Point Beach Nuclear Plant, Units 1 and 2
Dockets 50-266 and 50-301
Renewed License Nos. DPR-24 and DPR-27

License Amendment Request 261
Extended Power Uprate
Response to Request for Clarification

LICENSE AMENDMENT REQUEST 261 EXTENDED POWER UPRATE RESPONSE TO REQUEST FOR CLARIFICATION

FIGURE 1: Mass Calculations in SKBOR

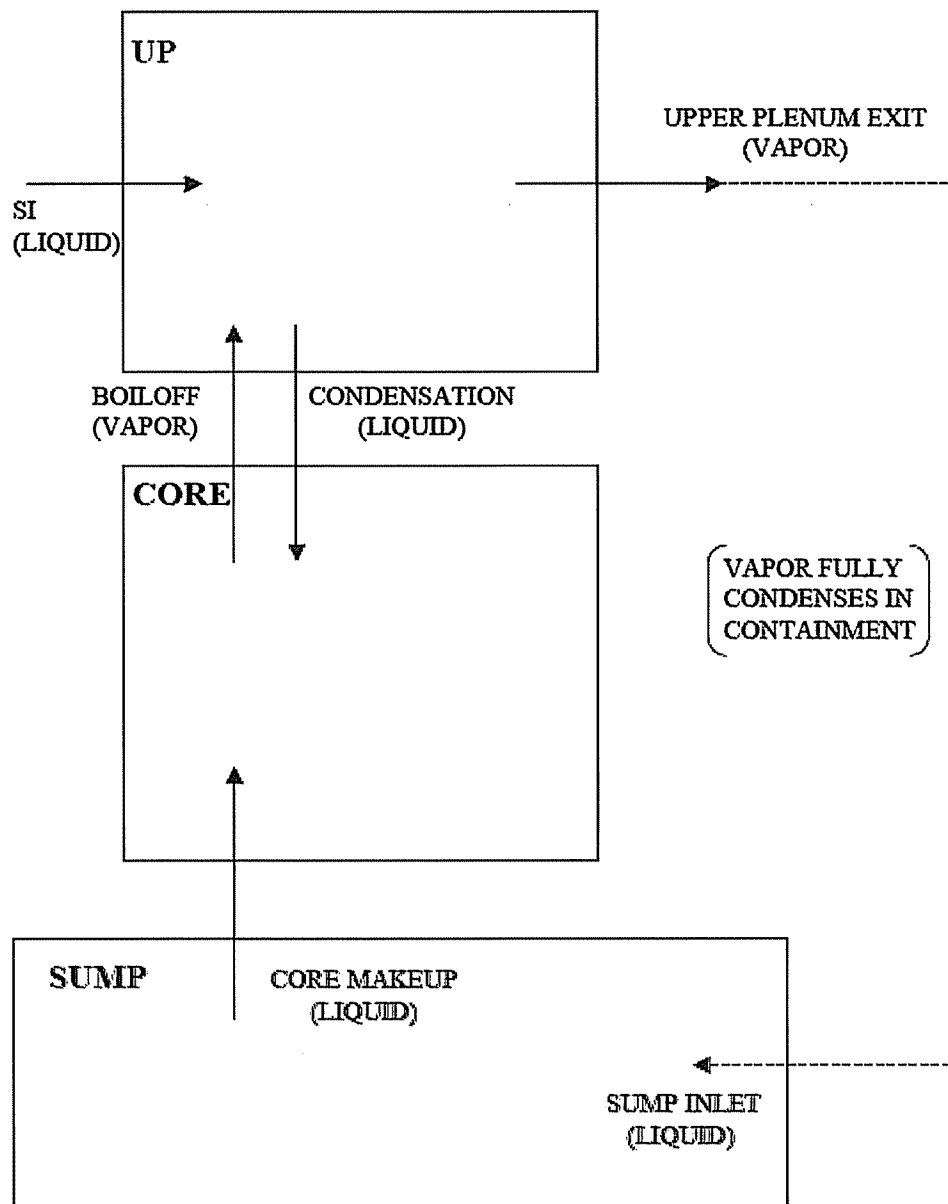
Please describe the models and method utilized to compute the boric acid concentration in the sump following sump re-circulation that is used as a boric acid source during the recirculation mode of injection.

Describe how the vapor source to the containment from the reactor coolant system is computed, the resultant condensation, and hence the boric acid content of the sump.

A typical SKBOR calculation considers two volumes: one representing the effective vessel mixing volume (denoted as the CORE); and one representing the remaining system inventory (denoted as the SUMP). The CORE and SUMP are initially assumed to contain borated liquid at the system-average boron concentration. Vapor generated due to decay heat boiling exits the CORE with a boron concentration of zero (vapor is assumed to condense fully in containment) and is returned to the SUMP as unborated liquid (see additional discussion below). Borated liquid is added from the SUMP as required to keep the CORE volume full. In this way, the

SUMP boron concentration gradually decreases, while the CORE boron concentration increases toward the boric acid solubility limit. The logic of the mass and boron calculations in SKBOR is shown in Figures 1 and 2.

FIGURE 3: PBNP EPU LOCA Containment Analysis – Relative Humidity

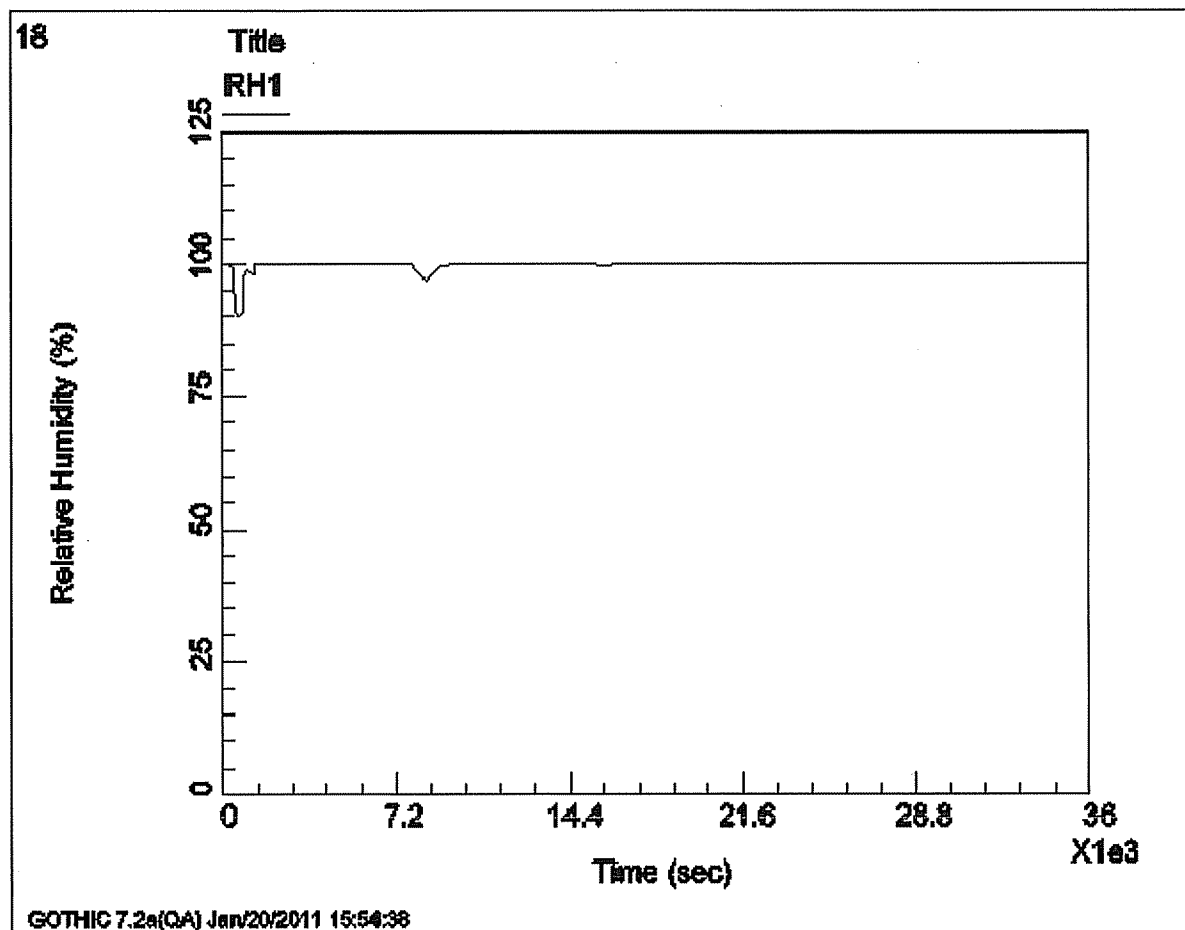
If 100% of the vapor source to the containment is assumed, then provide the basis and justification for this assumption.

If appropriate, please reference relevant containment transient data for the condensation efficiency of the containment sprays and CAR fans.

As described above SKBOR assumes that vapor generated in the core returns to the sump as unborated liquid (i.e. 100% condensation). The containment will reach saturated conditions (100% relative humidity) very quickly after the pipe break. At this point, since the containment atmosphere cannot hold any more water vapor, 100% of the steam generated in the core will condense. The amount of water vapor in the containment atmosphere, both before and after the pipe break is small relative to the amount of water in the sump. These assumptions are validated by examining the predicted conditions from the PBNP EPU LOCA Containment Analysis (Figures 3 and 4).

Figure 3 shows the relative humidity versus time for the limiting LOCA containment pressure analysis. As indicated, the relative humidity in containment rises to 100% very quickly, within seconds of the pipe break. There are several dips from 100% relative humidity related to the relatively rapid changes in containment pressure. The assumption that the amount of water vapor in the containment atmosphere is small relative to the amount of water in the sump can be justified by examining Figure 4, the containment water vapor mass (or steam mass) as a function of time after a large break LOCA. The maximum containment steam mass is approximately 100,000 lbm very early in the transient, and falls to approximately 25,000 lbm after about 3600 seconds. The water vapor mass in the containment atmosphere before the LOCA is approximately 1000 lbm. Thus, it is demonstrated that the containment atmosphere's retention of water vapor mass is small compared to the total water mass in the sump (approximately 2,700,000 lbm). The transients in Figures 3 and 4 are modeled assumptions to maximize containment pressure. A more representative condition for limiting boric acid precipitation scenarios would be a minimum containment pressure transient which is consistent with the minimum containment pressure assumption used in the boric acid precipitation analysis. Lower containment pressure would reduce the potential containment atmosphere retained water mass from what is indicated in Figure 4. The effect of 50,000 lbm of water vapor mass retained in the containment atmosphere on computed hot leg switchover (HLSO) time was examined by reducing the pure water mass in the SKBOR initial sump conditions. The effect on boric acid buildup in the core was small (time to reach 29.27 wt% boric acid concentration was 4.71 hours versus 4.82 hours).
